# Facility Impact and Funding Committee (FIFC) Report

11-January-2007

To evaluate validity and feasibility of the experiments planned in the Hadron Experimental Hall of J-PARC, the Facility Impact and Funding Committee (FIFC) of the Institute of Particle and Nuclear Physics (IPNS) was set up in the fall 2006.

Fig. 2.1 Layout of K1.8 beam line

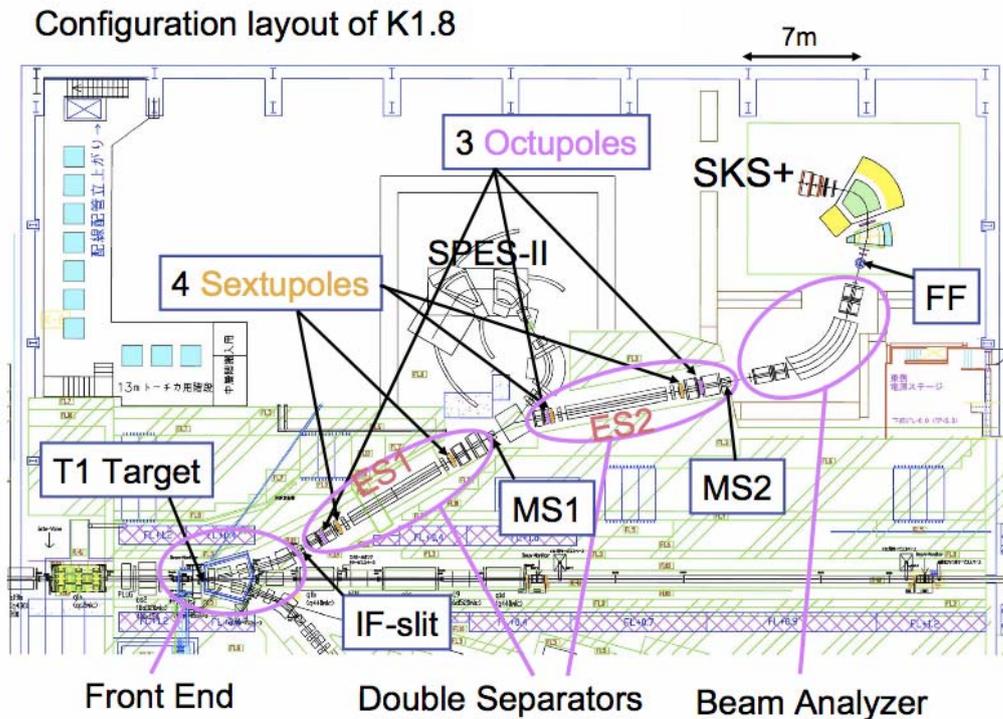
The committee agrees with the presented performance as a whole, although it wants to reserve some uncertainty in the estimate of  $K/\pi$  ratio. The counting rates in the tracking chambers are expected to be very high, especially at MS2. For the case of full-intensity operation some improvements on the tracking chambers should be necessary. This will be discussed more in the section 10.1.

Fig. 2.2 Layout of K1.8BR.

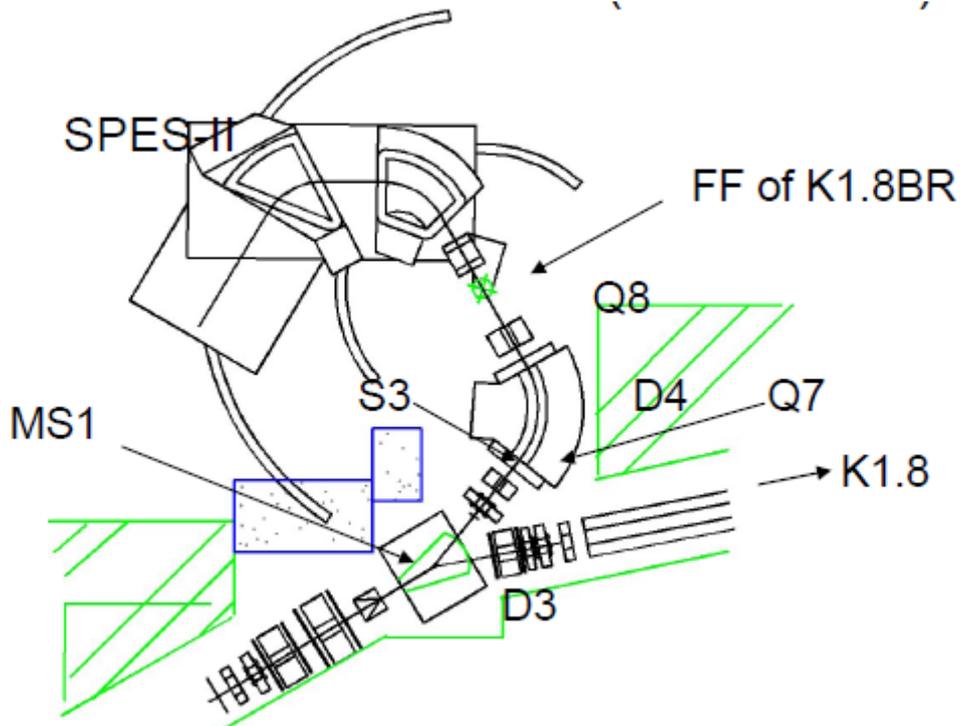
The committee accepts the proposed performance of this branch up to the  $K/\pi$  ratio which had better to be regarded with some ambiguity ( more than K1.8). As was pointed out in the simulation calculation by Dr. Doornbos, the committee was concerned about the muon contamination in the beam, since it could influence on the experimental conditions and thus the detector design significantly. The committee recommends both the beamline designers and the users to evaluate it seriously soon.

Fig. 3.1 SKS Spectrometer.

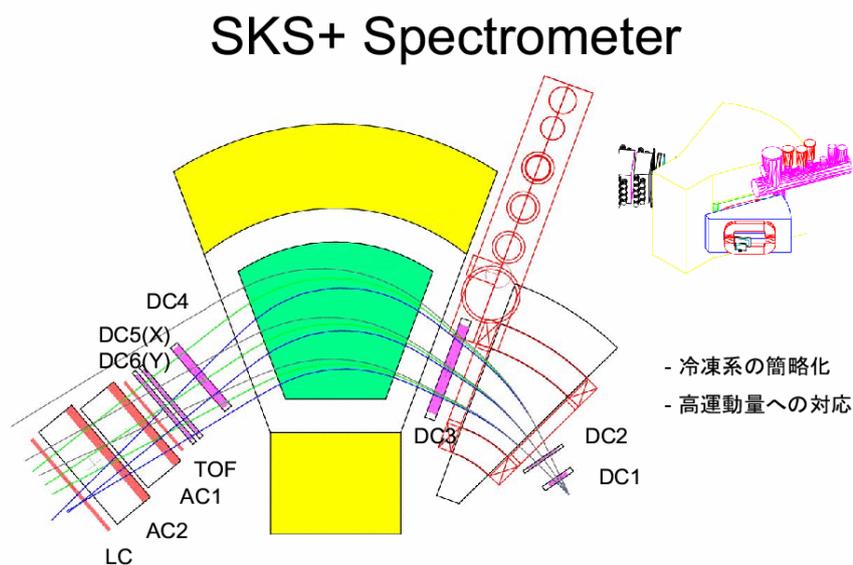
resolution ( $\sigma \sim 100 \mu\text{m}$ ) chambers as proposed in E13. This was checked to be possible by the E05 group themselves using an improved simulation. However, the size of the chambers must be wider because the beam would be focused weakly, and it seems difficult to keep the original resolution of  $\sigma \sim 100 \mu\text{m}$  for a long time over such a wide area. Therefore, the committee endorses the original plan with the addition of the "D" magnet.

Fig. 6.2 Sensitivity dependence on statistics. The  $x$ -axis shows ratio to statistics at the Phase I full intensity beam condition

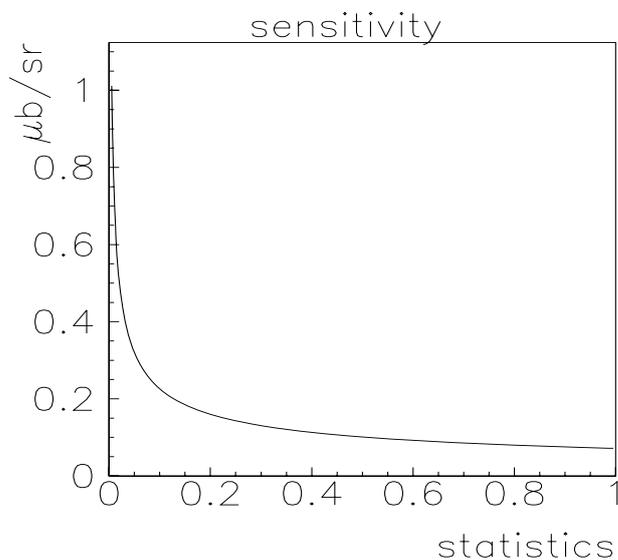
2) Optimization of statistics and feasibility should be considered in a reasonable manner. As shown in the figure above, a significant sensitivity would be achievable with rather low statistics (namely low beam intensity). The reasonable goal of the experiment should be discussed in PAC.

Fig. 7.1 Layout of E07 experiment.

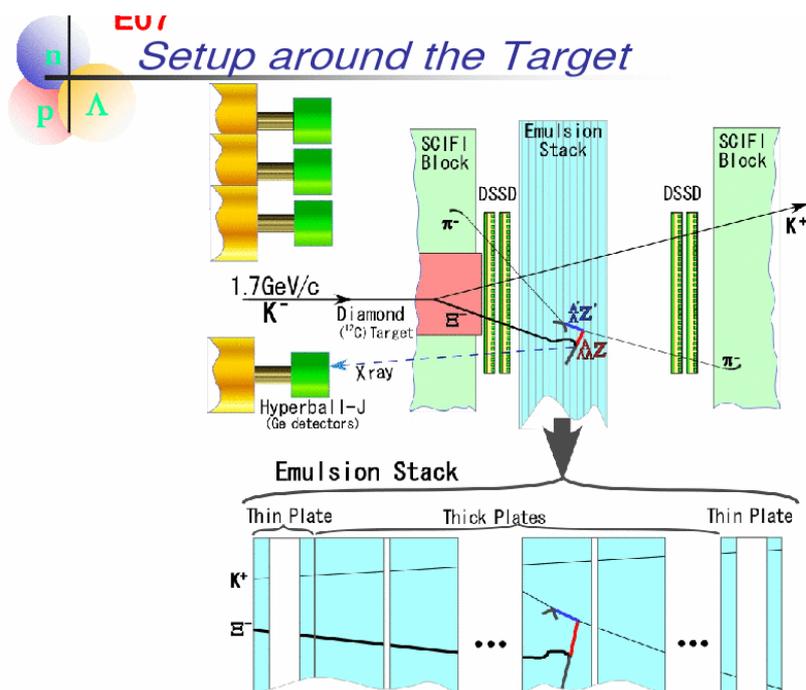
The committee does not foresee any technical problems in this setup and basically endorses the original design of the experiment. However, there are two concerns raised. One is related to the choice of a spectrometer magnet. The use of the SKS magnet instead of the originally proposed KURAMA would reduce the acceptance by a factor 2. This reduction will reflect directly to the total amount of the emulsion. Apparently there is no strong reason to use SKS unless a technical difficulty to remove SKS or to let KURAMA coexist with SKS is encountered. Therefore the committee favors the use of KURAMA for this experiment.

Another concern is on the method to align two DSSDs and the emulsion stack. It is normally achieved using a high statistics beam data. However, it might be difficult to use tracks recorded in the emulsion for this purpose since the stack is frequently replaced and number of tracks used for the alignment is limited. Since the question has not yet answered to by the experiment, the committee expects to hear the strategy on this issue from the group at the coming PAC.

Figure 10.1 K1.8 beam-line. Two gas chambers (BC1 and BC2) are installed near MS2 (mass slit) and, three (BC3, BC4 and DC1) are installed near FF in K1.8 for tracking of incident particle.

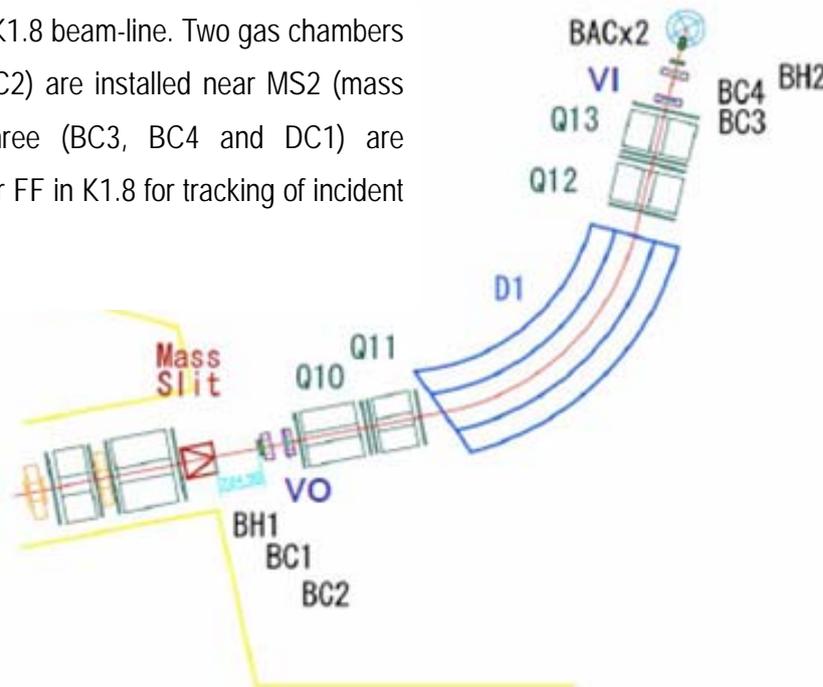
BC1, BC4 and DC1 operation where the beam profile is expected to be smaller than those on BC2 or BC3.
